To: Ibiz Design
Project: Warakirri College
Report: Access Assessment Report
Reference No: 110810-Access-r2
Date: 22 October 2019
Client Contact: Tony Whaling
Email: tw@ibizdesign.com.au
From: Cameron Clark
Direct: (02) 8484 4095
Email: cclark@bcalogic.com.au

1 BASIS OF ASSESSMENT

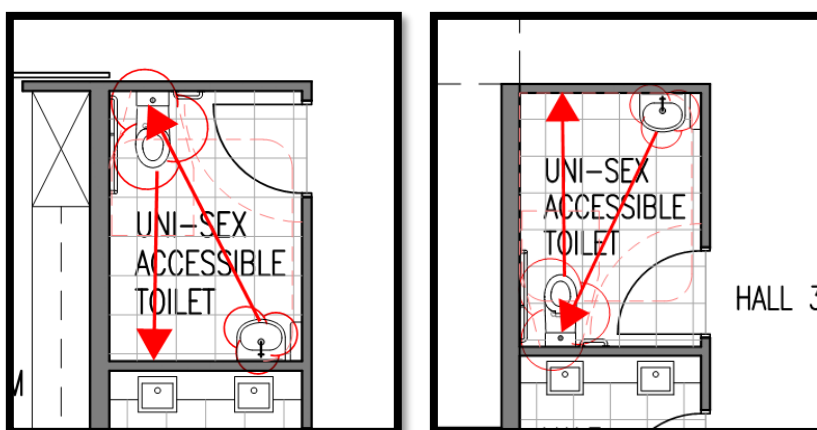
4.2.1 Accessible Toilets

Currently, compliant circulation with AS1428.1-2009 is not achieved in the unisex accessible sanitary compartments. To address the circulation space non-compliances, the toilet and handbasin may be relocated, as shown below. It is important to ensure that the swing of the door arc is not less than 300mm from the nearest part of the handbasin.

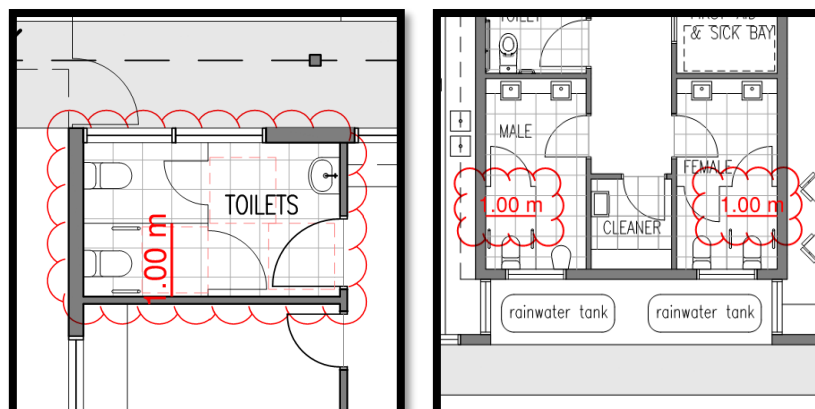
4.2.2 Ambulant Cubicles

Ensure ambulant cubicles are provided for both male and female staff. Currently, sanitary facilities are provided for the use of only either male or female (this is not specified which sex), and this would be a technical non-compliance.

The ambulant sanitary compartments throughout shall also be between 900mm and 920mm in width. Currently, these are shown to be 1000mm in width, which would be a technical non-compliance.
